H. B. ROBINSON STEAM ELECTRIC PLANT, UNIT NO. 2
DOCKET NO. 50-261/LICENSE NO. DPR-23

RESPONSE TO REQUEST FOR ADDITIONAL INFORMATION
FOR RELIEF REQUEST PERTAINING TO EXAMINATION COVERAGE
LESS THAN ESSENTIALLY 100 PERCENT (RELIEF REQUEST NO. 34)

RESPONSE TO REQUEST FOR ADDITIONAL INFORMATION FOR RELIEF REQUEST PERTAINING TO EXAMINATION COVERAGE LESS THAN ESSENTIALLY 100 PERCENT (RELIEF REQUEST NO. 34)

COMPONENT ID:	202/03	ASME CATEGORY:	C-B
ASME CODE FIGURE:	IWC-2500-4(a)	ASME ITEM NUMBER:	C2.21
CONFIGURATION:	BOTTOM HEAD TO NOZZLE	% CRV ACHIEVED:	74.25%
PDI TECHNIQUE USED:	NO	EXAM DATE:	4/26/01

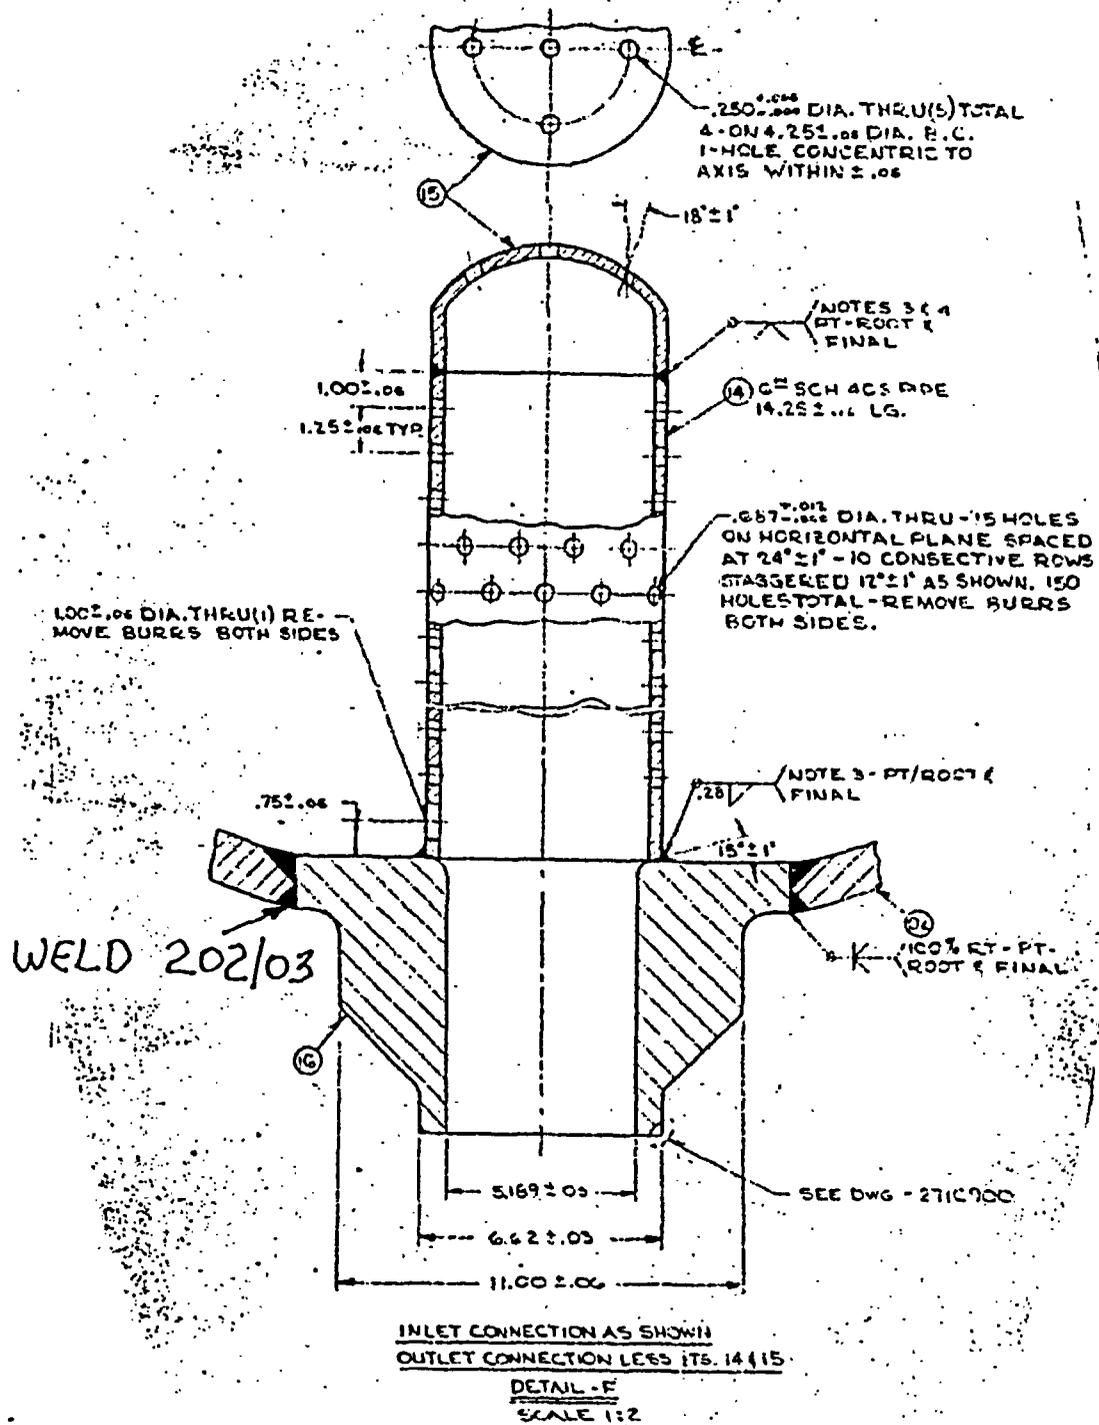
SCAN	% VOLUME ACHIEVED	LIMITATION
1	62%	LIMITED SCAN DUE TO HEAD TO NOZZLE CONFIGURATION.
2	20%	LIMITED SCAN DUE TO HEAD TO NOZZLE CONFIGURATION.

COMPONENT ID:	202/04	ASME CATEGORY:	C-B
ASME CODE FIGURE:	IWC-2500-4(a)	ASME ITEM NUMBER:	C2.21
CONFIGURATION:	UPPER HEAD TO NOZZLE	% CRV ACHIEVED:	84%
PDI TECHNIQUE USED:	NO	EXAM DATE:	4/24/01

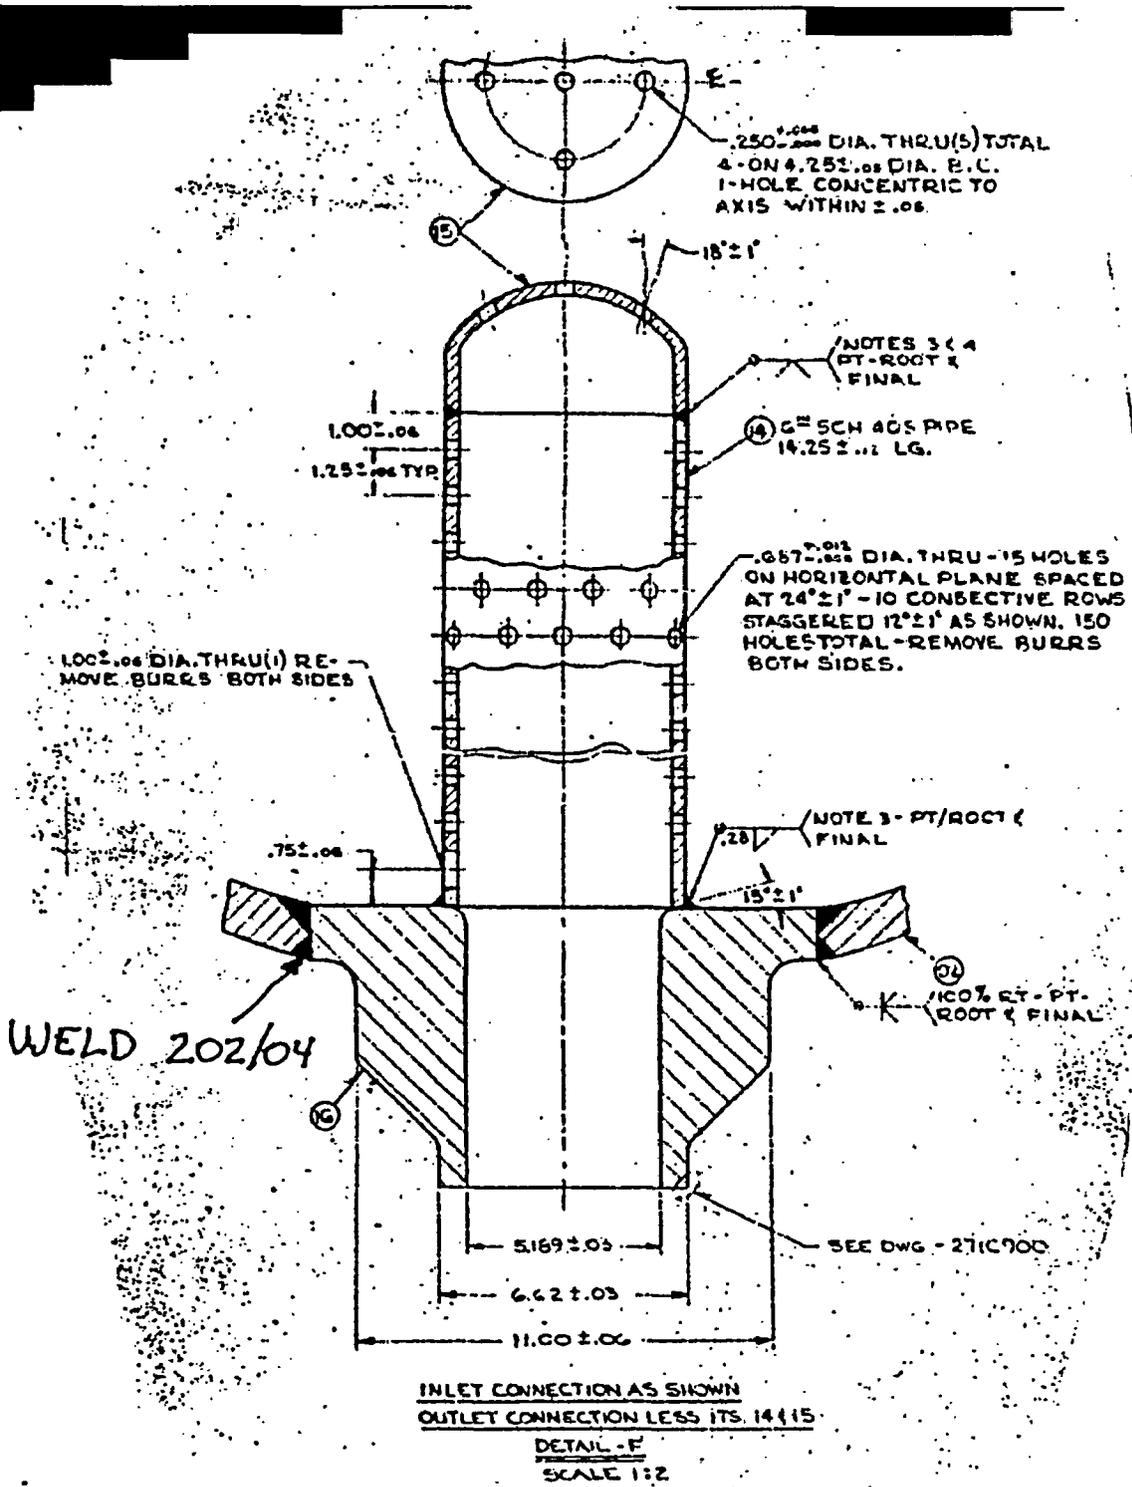
SCAN	% VOLUME ACHIEVED	LIMITATION
1	82%	LIMITED SCAN DUE TO HEAD TO NOZZLE CONFIGURATION.
2	68%	LIMITED SCAN DUE TO HEAD TO NOZZLE CONFIGURATION.

COMPONENT ID:	205/08	ASME CATEGORY:	C-B
ASME CODE FIGURE:	IWC-2500-4(a)	ASME ITEM NUMBER:	C2.21
CONFIGURATION:	UPPER SHELL TO FEEDWATER NOZZLE	% CRV ACHIEVED:	53%
PDI TECHNIQUE USED:	NO	EXAM DATE:	9/29/93

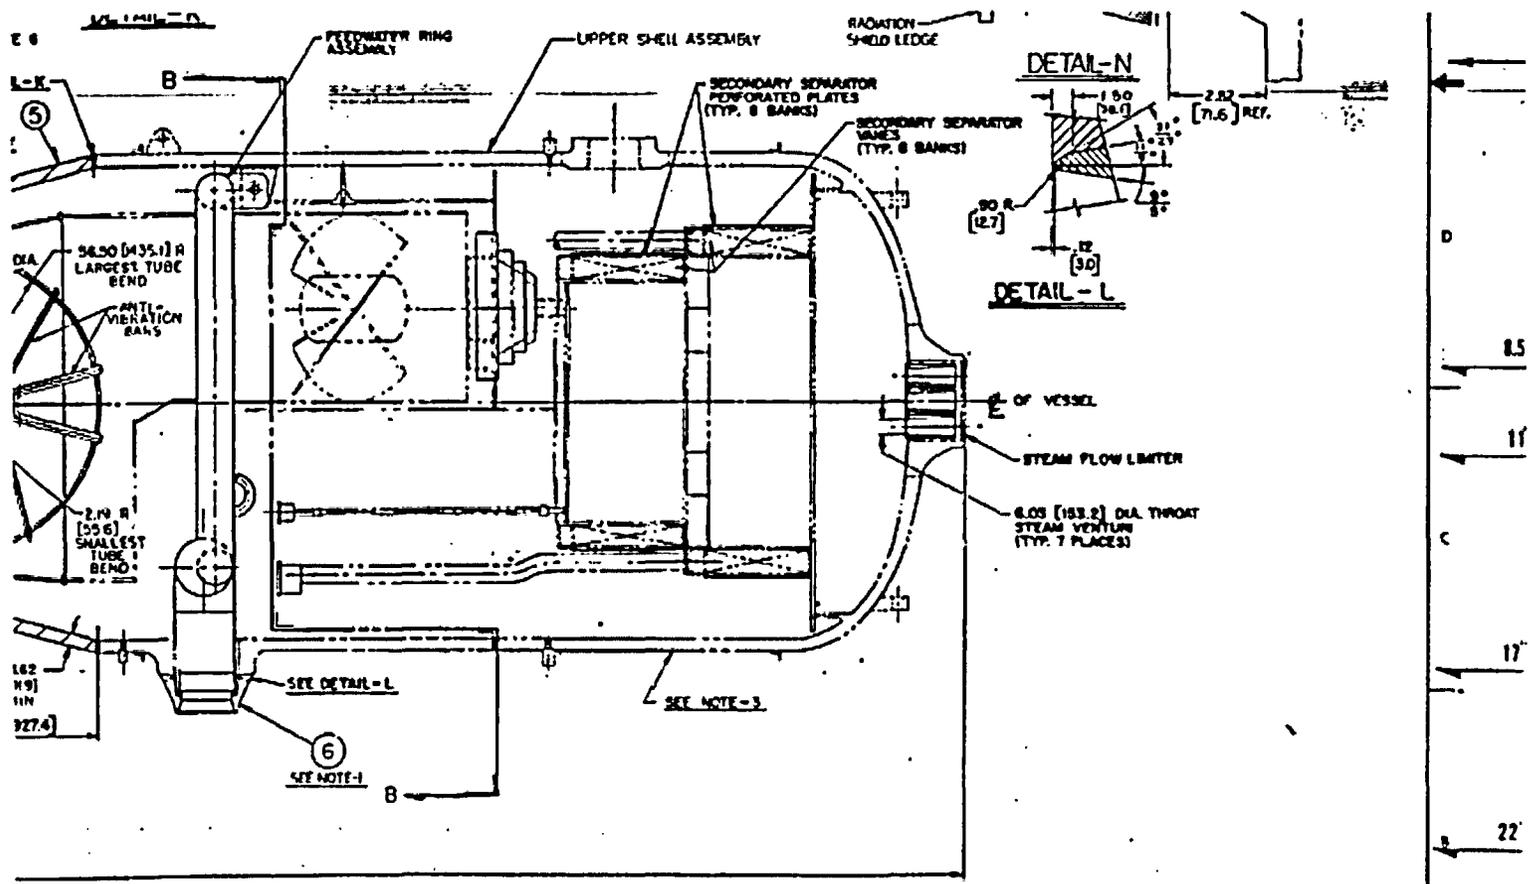
SCAN	% VOLUME ACHIEVED	LIMITATION
1	66%	COMPONENT NOZZLE TO SHELL CONFIGURATION.

COMPONENT ID:	205A/07	ASME CATEGORY:	C-B
ASME CODE FIGURE:	IWC-2500-4(a)	ASME ITEM NUMBER:	C2.21
CONFIGURATION:	STEAM GENERATOR UPPER HEAD TO STEAM NOZZLE	% CRV ACHIEVED:	44%
PDI TECHNIQUE USED:	NO	EXAM DATE:	3/18/98

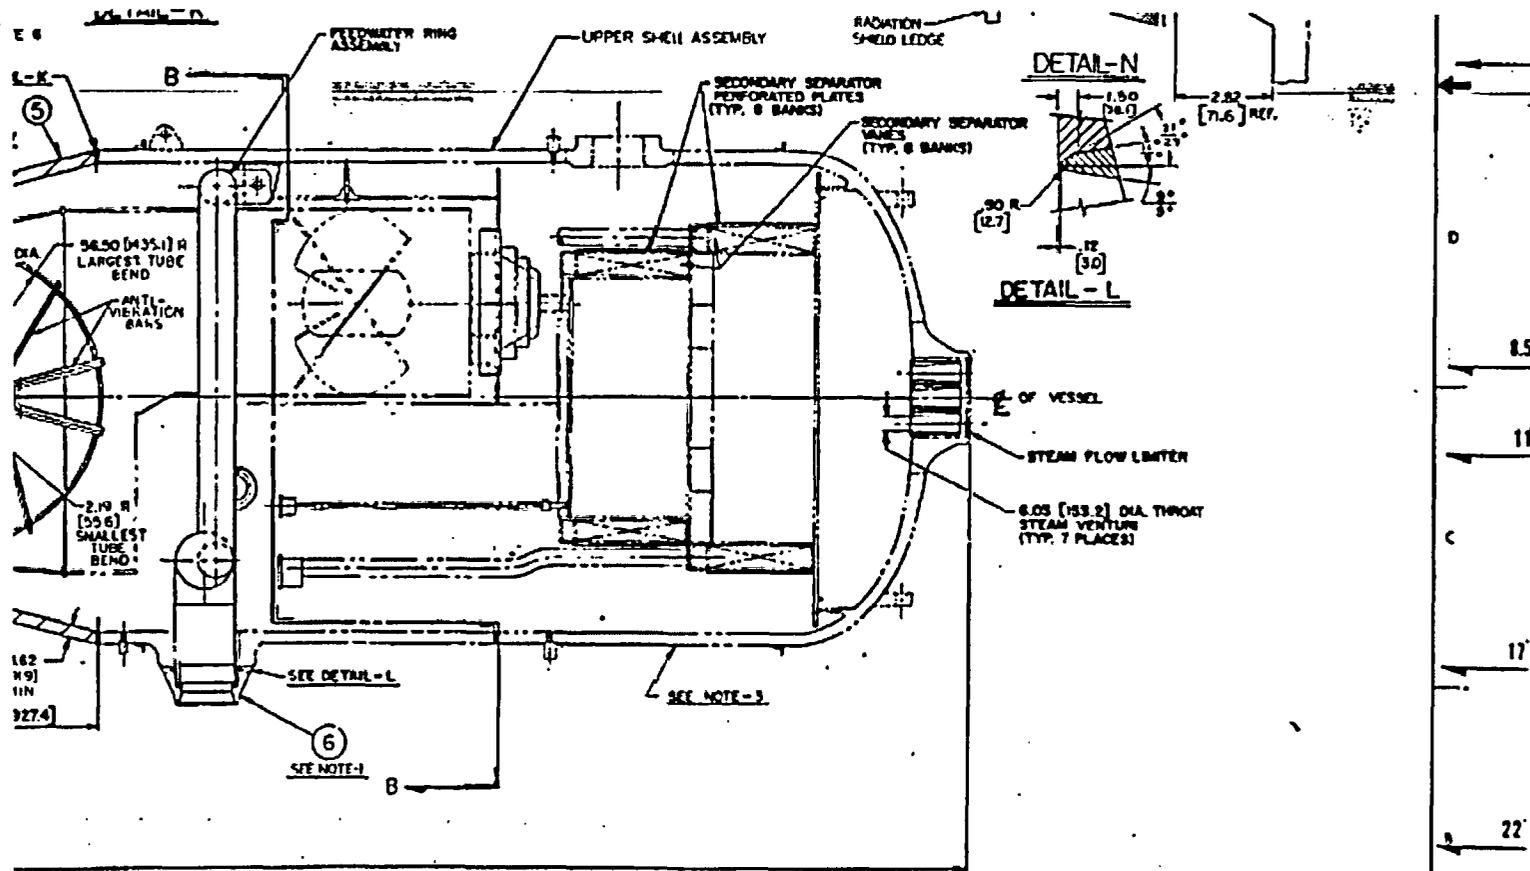
SCAN	% VOLUME ACHIEVED	LIMITATION
1	100%	NONE
2	0%	NO SCAN - BEAM IS OUTSIDE THE CODE-REQUIRED VOLUME.
3	35%	LIMITED EXAM DUE TO NOZZLE CONFIGURATION AND WELD CROWN.
4	35%	LIMITED EXAM DUE TO NOZZLE CONFIGURATION AND WELD CROWN.

COMPONENT ID:	205A/08	ASME CATEGORY:	C-B
ASME CODE FIGURE:	IWC-2500-4(a)	ASME ITEM NUMBER:	C2.21
CONFIGURATION:	UPPER SHELL TO FEEDWATER NOZZLE	% CRV ACHIEVED:	56%
PDI TECHNIQUE USED:	NO	EXAM DATE:	3/18/98

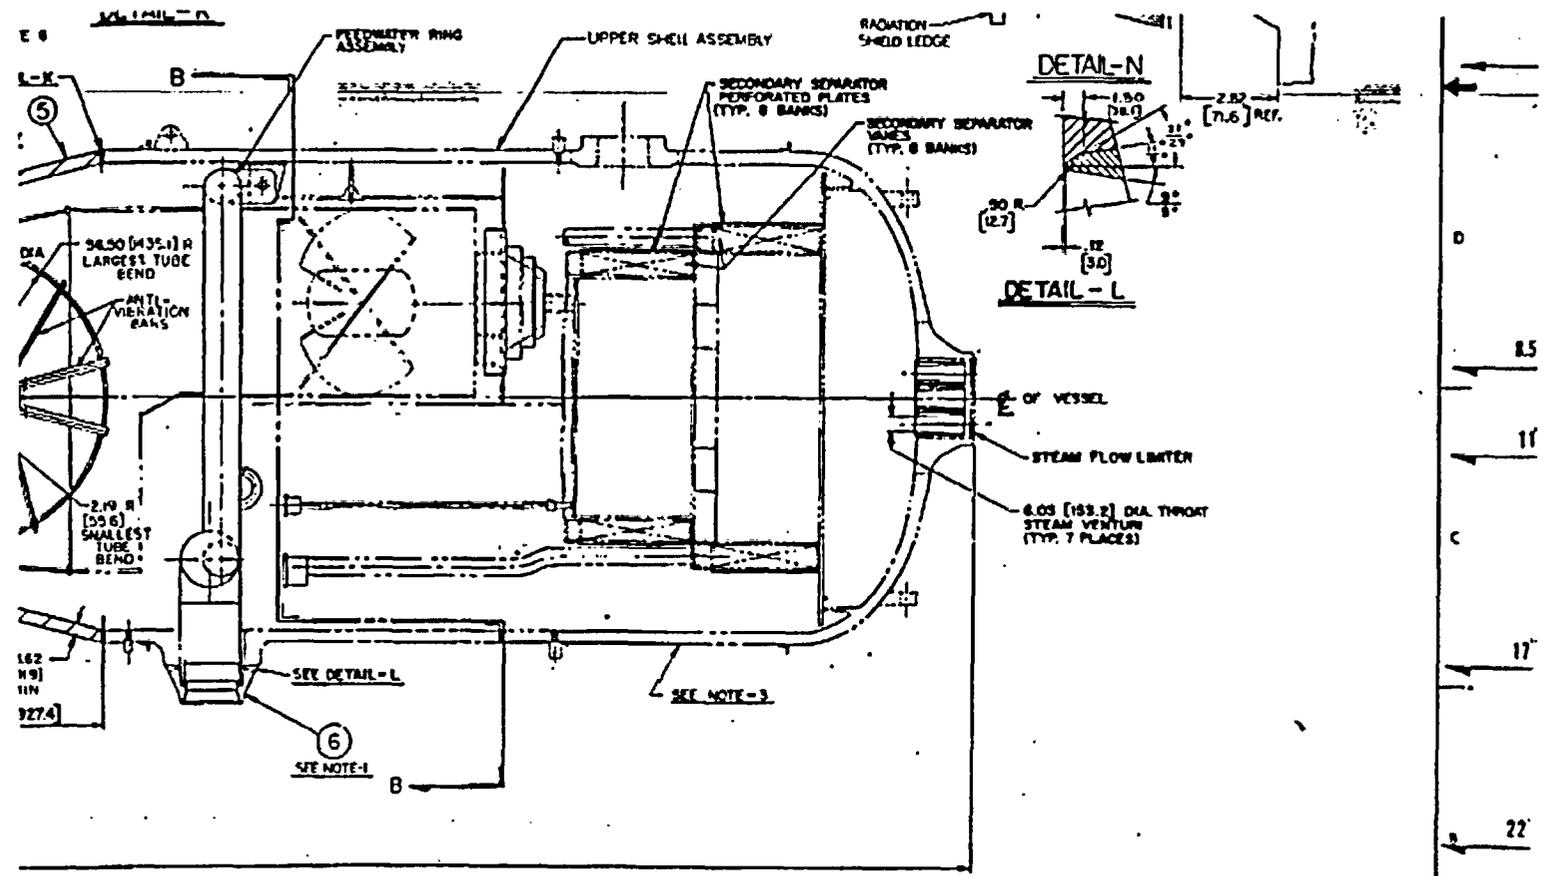
SCAN	% VOLUME ACHIEVED	LIMITATION
1	91%	COMPONENT NOZZLE TO SHELL CONFIGURATION.

COMPONENT ID:	112/19	ASME CATEGORY:	B-J
ASME CODE FIGURE:	IWB-2500-8	ASME ITEM NUMBER:	B9.11
CONFIGURATION:	TEE TO ELBOW	% CRV ACHIEVED:	66%
PDI TECHNIQUE USED:	YES	EXAM DATE:	4/22/01

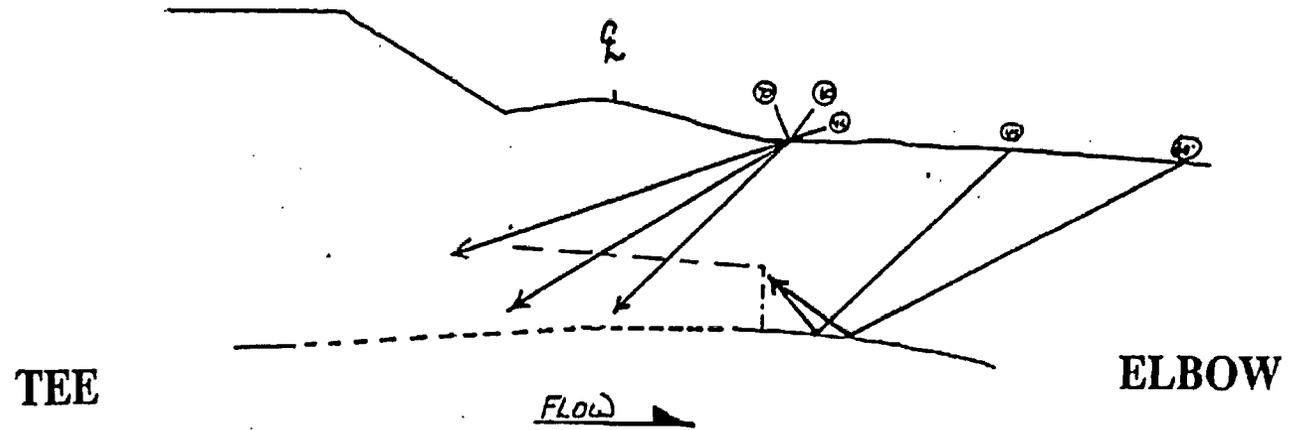
50% CODE REQUIRED COVERAGE OBTAINED FROM SCANNING SINGLE SIDED. HOWEVER, SCREEN RANGE WAS ESTABLISHED TO ENCOMPASS AN ADDITIONAL 1/3 "T" BUT, DUE TO GRAIN STRUCTURE AND METALLURGICAL CONDITIONS, THIS ADDITIONAL COVERAGE CAN NOT BE CLAIMED.

COMPONENT ID:	219A/203	ASME CATEGORY:	C-F-1
ASME CODE FIGURE:	IWC-2500-7	ASME ITEM NUMBER:	C5.11
CONFIGURATION:	REDUCER TO PIPE	% CRV ACHIEVED:	75%
PDI TECHNIQUE USED:	YES	EXAM DATE:	4/26/01

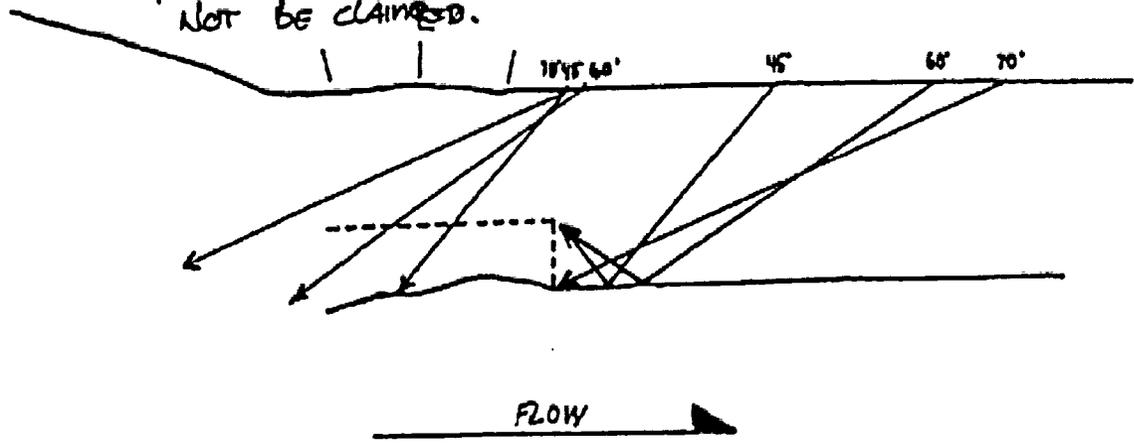
SCAN	% VOLUME ACHIEVED	LIMITATION
1	0%	NO SCAN DUE TO REDUCER TO PIPE CONFIGURATION.
2	100%	NONE

INTEGRAL ATTACHMENT F-NS

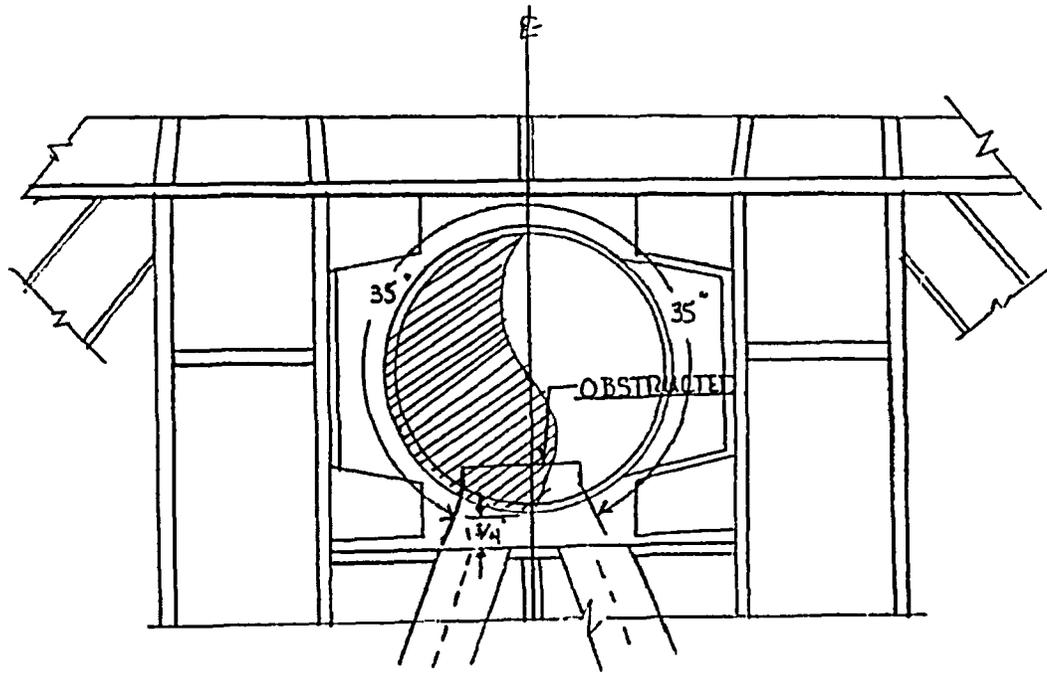
* The magnetic particle examination of this support was limited due to the configuration. The coverage is estimated at 84% of the Code-required surface (CRS). See CRS sketches for surface examination coverage limitations.

TOTAL PIPE CIRCUMFERENCE 82 7/8"
AREA EXAMINED 70"
